Committee Report

Planning Committee South – 26 October 2021

Application no DC/20/3284/FUL

Proposal Full Planning Application for the erection of 70 dwellings, including affordable dwellings, together with public open space, roads, accesses, parking, garages, drainage and associated infrastructure

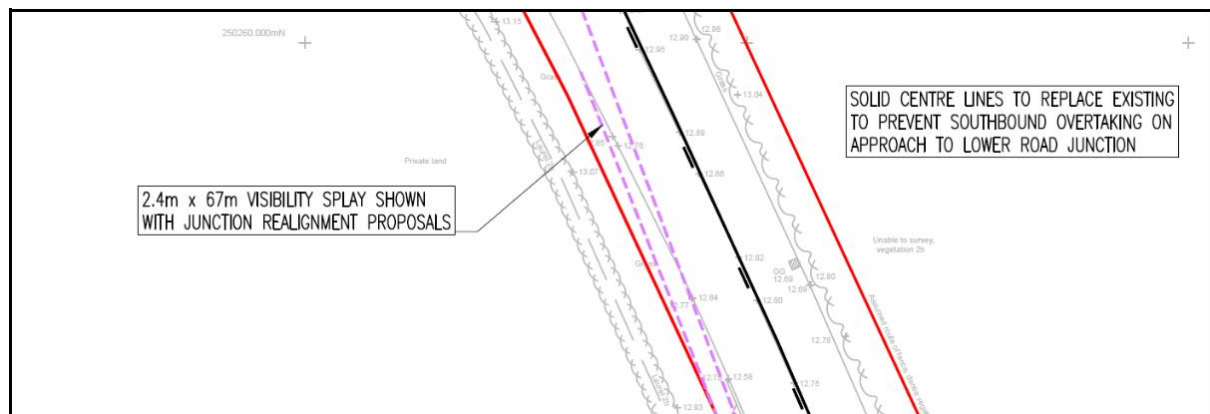
- 2.32 The assessment of layout is not deficient and neither is evidence necessary at this stage.

Notwithstanding, in order to expedite the Councils decision making process, swept path analysis drawings have been prepared and are included at Appendix A The Swept paths are based on vehicle details provided by Norse Group who provide the local services to East Suffolk and Grundsiburgh. They show the refuse vehicle tracking of the submitted layout allows for the vehicle to enter and leave in a forward gear.

B1079 Woodbridge Road /Lower Road junction

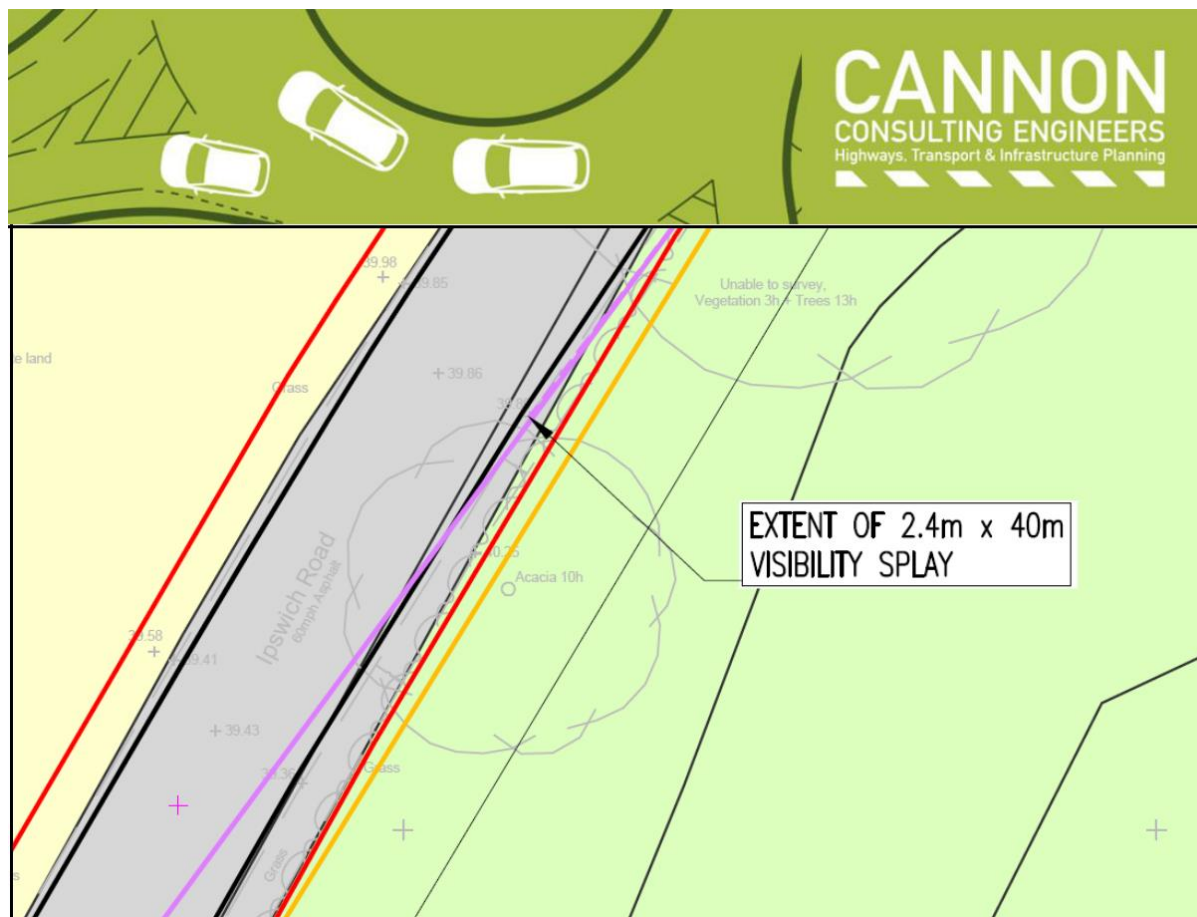
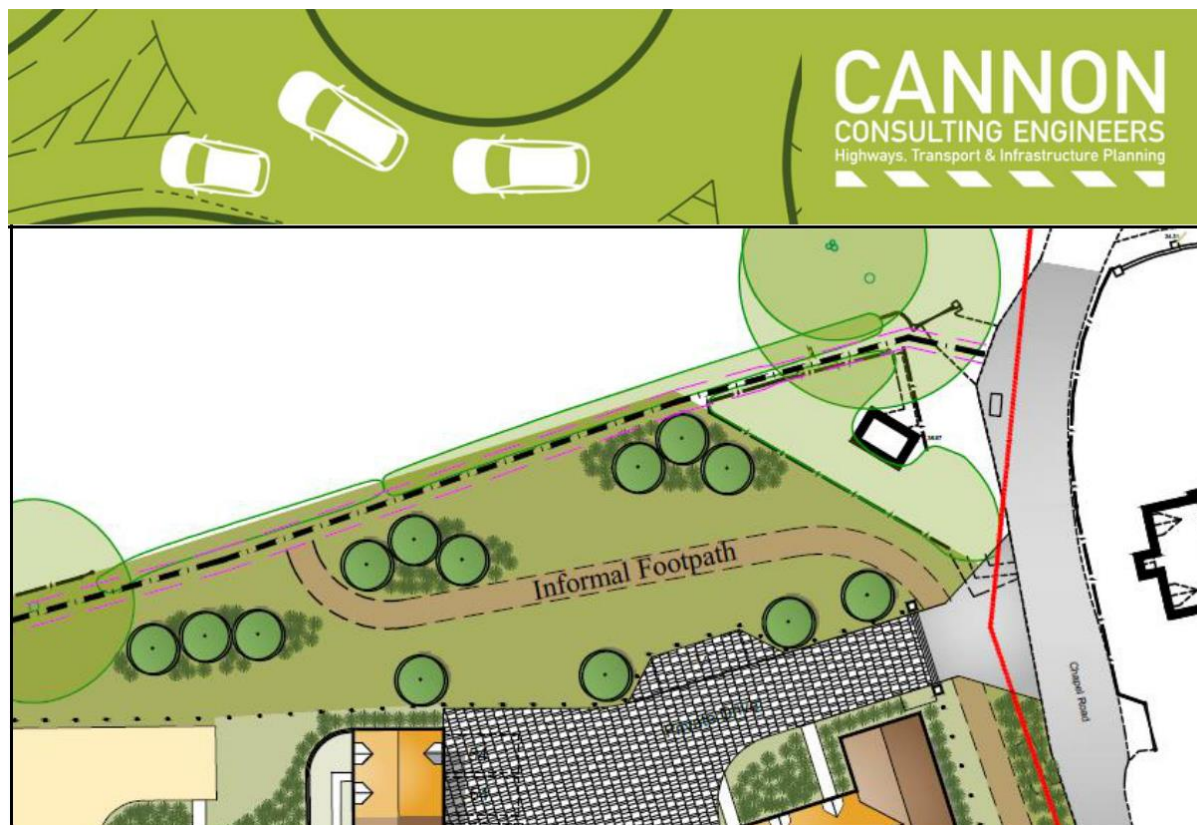
2.33 Provide visibility splays in compliance to design standards.

- 2.38 This is not a deficiency. Inspection of the drawings shows the splays have been correctly shown and are not misrepresenting the visibility splays that can be achieved at the improved junctions.
- 2.39 Improvements have been provided and considered acceptable by the Highway Authority.

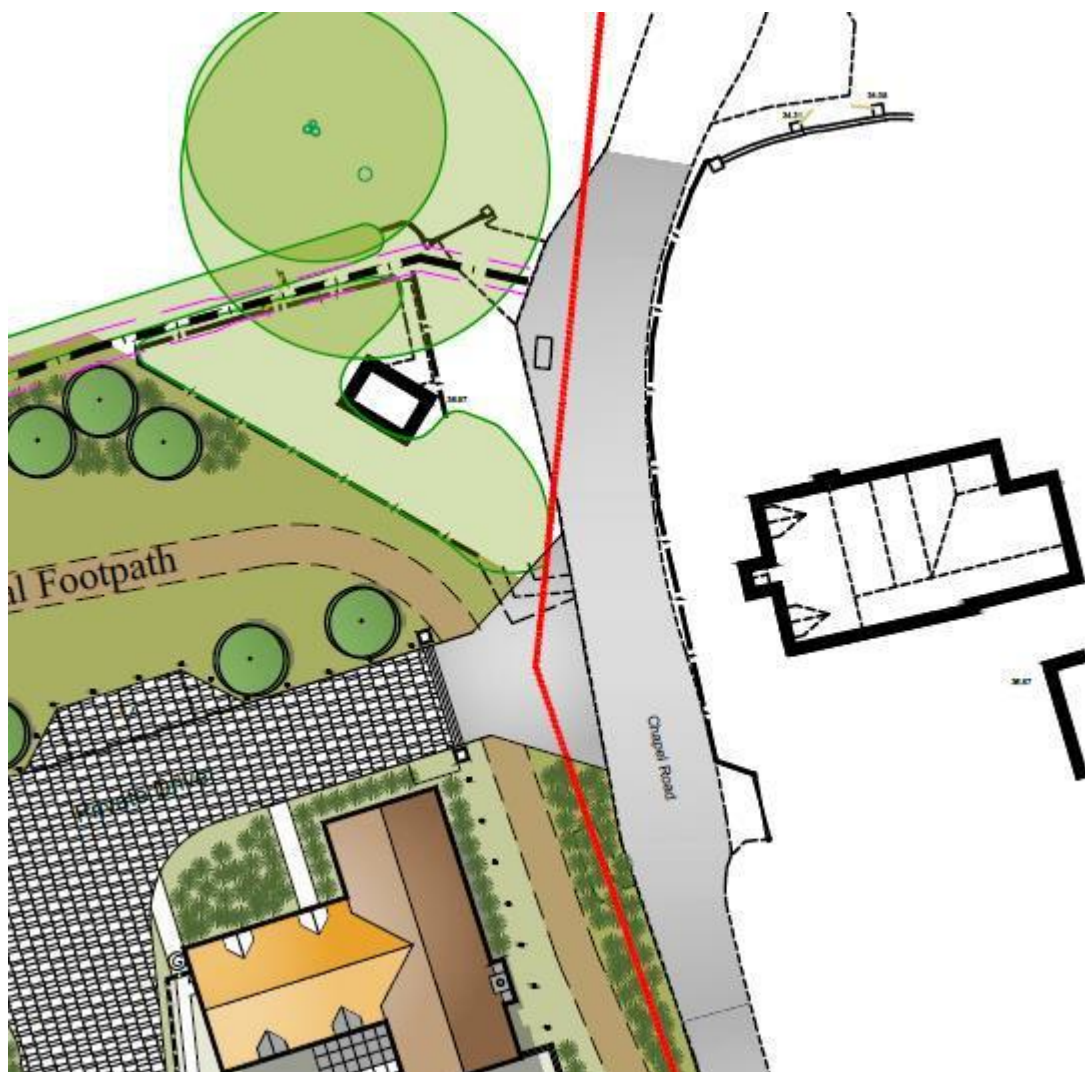
- 2.67 For reasons outlined above in relation to providing for the needs of cyclists in a village where the local roads are lightly trafficked and no other facilities are provided it is not considered necessary to upgrade the footpath to a bridleway which would only be over a short length. Cyclists would then be required to dismount to use footways or re-join the carriageway to continue any journey. The local highway network and 'Quiet Lanes' are appropriate to accommodate the cycle needs of the development. A dedicated cycle connection will also be provided from the site to Chapel Road.

- 2.68 SCC has been asked to consider this point in relation to conversion to a bridleway and concluded this is not achievable and that a cycle connection onto Chapel Road is appropriate.
- 2.69 Protecting pedestrians from unlawful use of FP20 by cyclists will be included in the upgrading works which is subject to a condition that will need to be discharged. The condition references a drawing that shows the width to be surfaced relating to the defined public right of way. Further detail will need to be approved prior to completion of the works under S.278 and this process is the appropriate mechanism to deal with such detail if considered necessary by SCC.

Extract from Drawing 1812-296 305C – Grundisburgh Footpath 20 Improvements

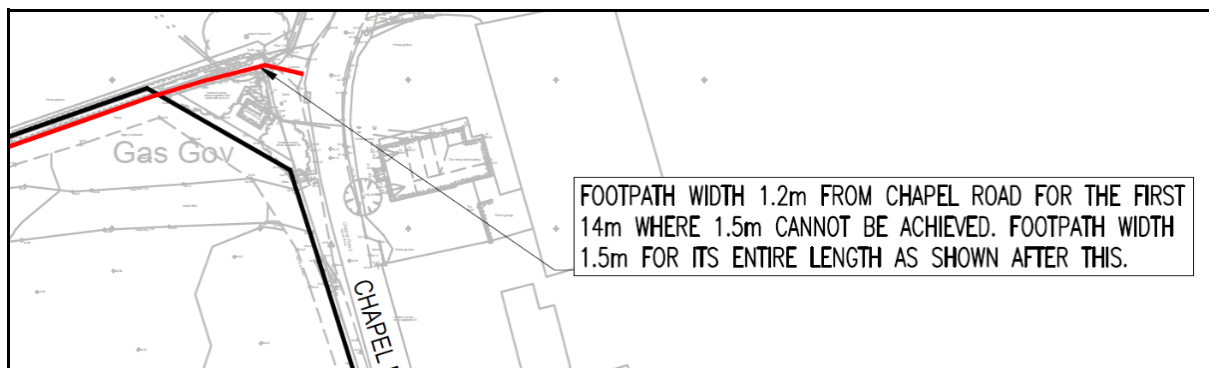
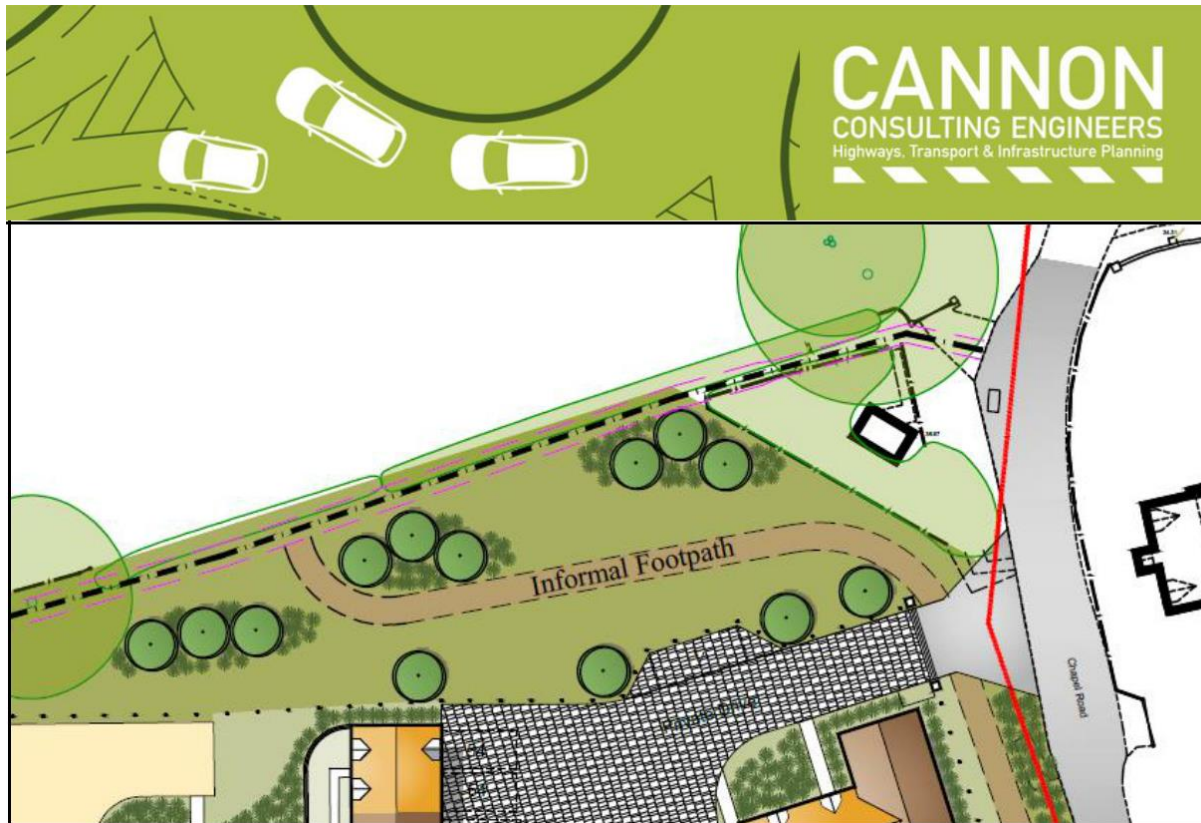
2.73 FP20 should be widened to 1.5m on the entirety

2.74 The accepted improvement to FP20 which is within the defined route includes a short section of 14m which is 1.2m.

2.77 This requirement is met for the entirety of the route of FP20 from Chapel Road/Meeting Lane.
